# UNITED STATES PATENT AND TRADEMARK OFFICE

APPLICATION NO.	FILING DATE	FIRST NAMED INVENTOR	ATTORNEY DOCKET NO.	CONFIRMATION NO.
10/579,318	05/16/2006	Tatsuro Iwasaki	2950-061389	1885

<b>Office Action Summary</b>	<b>Application No.</b> 10/579,318	<b>Applicant(s)</b> IWASAKI ET AL.	
	<b>Examiner</b> Sunil Singh	<b>Art Unit</b> 3672

## DETAILED ACTION

Fig.1

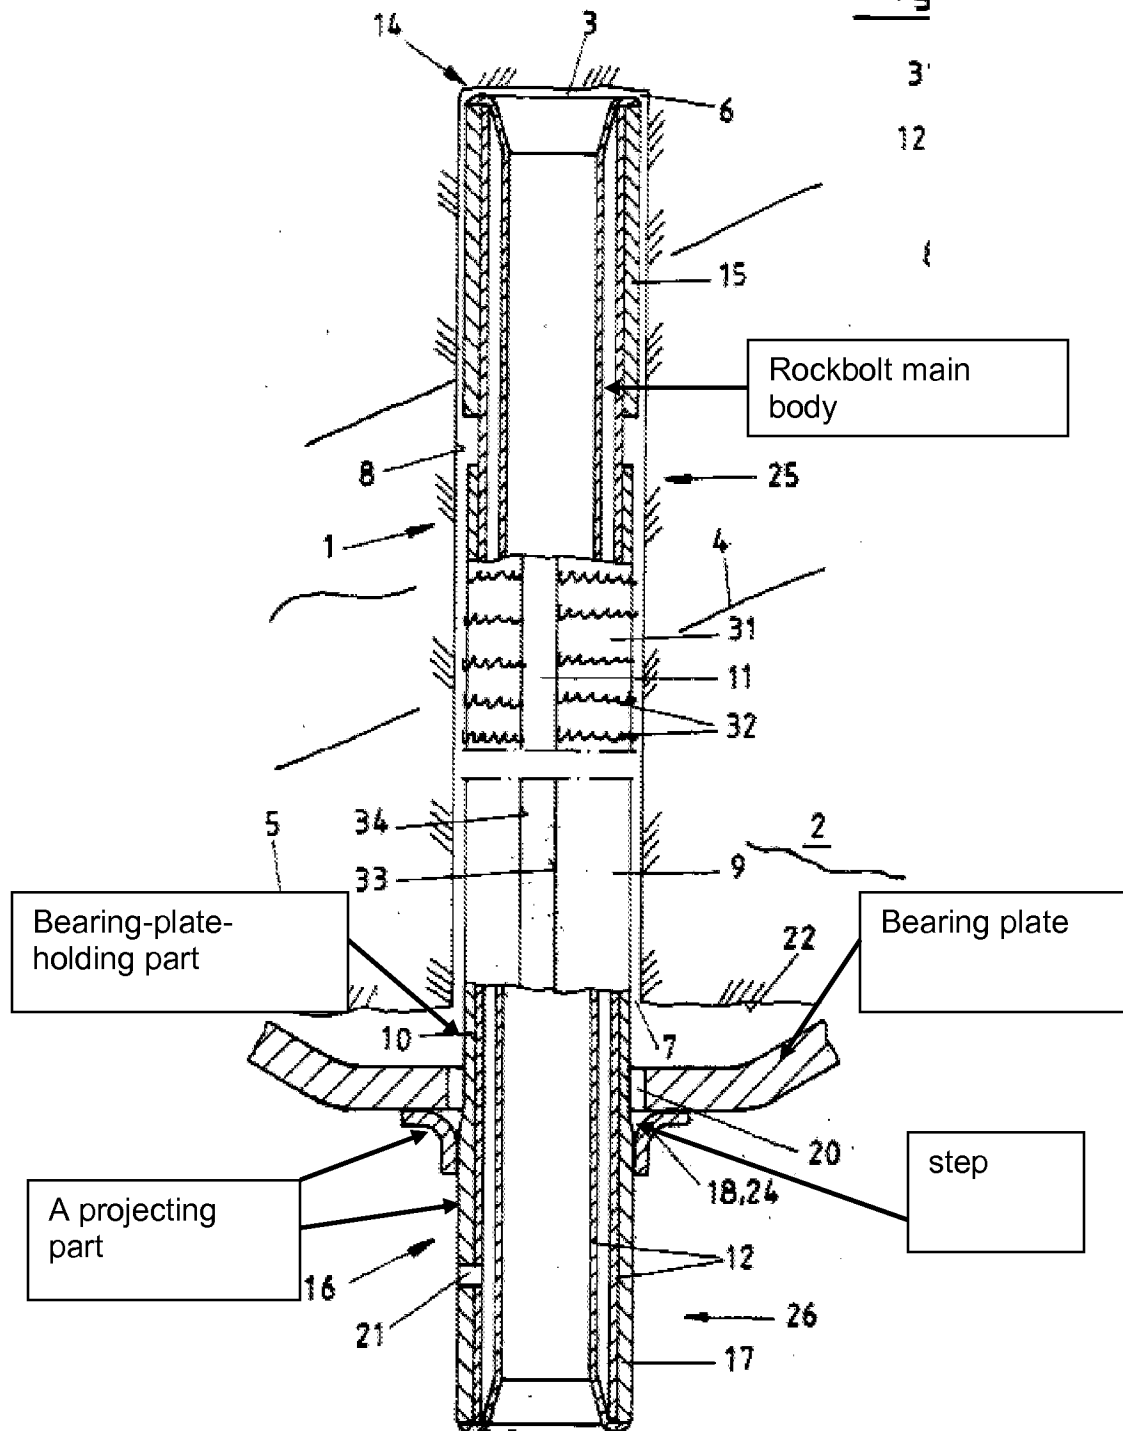
German document discloses a steel pipe rockbolt (see Fig. 1), comprising a rockbolt main body (12, see marked up Fig. below) and a pressurized-fluid-introducing sleeve (10,17, see marked up Fig. 1 below) fixed to the rockbolt main body at an end for introduction of a pressurized fluid, wherein the rockbolt main body is a deformed pipe having an expansive groove (see Figs. 2-4) extending along an axial direction of the deformed pipe, and wherein the rockbolt main body is configured to hydraulically expand upon the introduction of the pressurized fluid, the pressurized-fluid-introducing sleeve comprising a projecting part (see marked up Fig. below) with an outer diameter larger than a diameter of an aperture (20) of a bearing plate (see marked up Fig. below) and a pressurized-fluid-introducing hole (21), and a bearing-plate-holding part (see marked up Fig. below) with an outer diameter smaller than the diameter of the aperture of the bearing plate, the projecting part and the bearing-plate-holding part defining a passageway, a portion of the expansive groove of the rockbolt main body being

positioned within the passageway, whereby the bearing plate is held in contact with a step between the projecting part and the bearing-plate-holding part, whereby the bearing plate locates on an edge of a rockbolt-setting hole drilled in a bedrock or ground, and the bearing-plate-holding part extends through the aperture of the bearing plate into the rockbolt-setting hole. German document discloses the invention substantially as claimed. However, German document is silent about the sleeve being fixed by welding to the rockbolt main body. Further, German document is silent about the projecting part and the bearing-plate-holding part being a single, one-piece unitary construction, the projecting part being fixed relative to the bearing-plate-holding part. Skogberg et al. '899, '317 both disclose a sleeve fixed by welding (see col. 3 lines 3-4, col. 3 lines 5-6) to a rockbolt main body. It would have been considered obvious to one of ordinary skill in the art to modify German document by fixing the sleeve to the rockbolt via welding as taught by either Skogberg et al. '899 or '317 since such a modification would prevent the unwanted longitudinal movement between the parts. Further, it would have been considered obvious to one of ordinary skill in the art to modify German document so as to have the projecting part and the bearing-plate-holding part be a single, one-piece unitary construction, the projecting part being fixed relative to the bearing-plate-holding part since it has been held that forming in one piece an article which has formerly been formed in two pieces and put together involves only routine skill in the art. *Howard v. Detroit Stove Works*, 150 U.S. 164 (1893). With regards to claim 2, it would have been considered obvious to modify German

document to have a circumferential groove on the projecting part since such a modification allows for gripping of the sleeve during assembly.
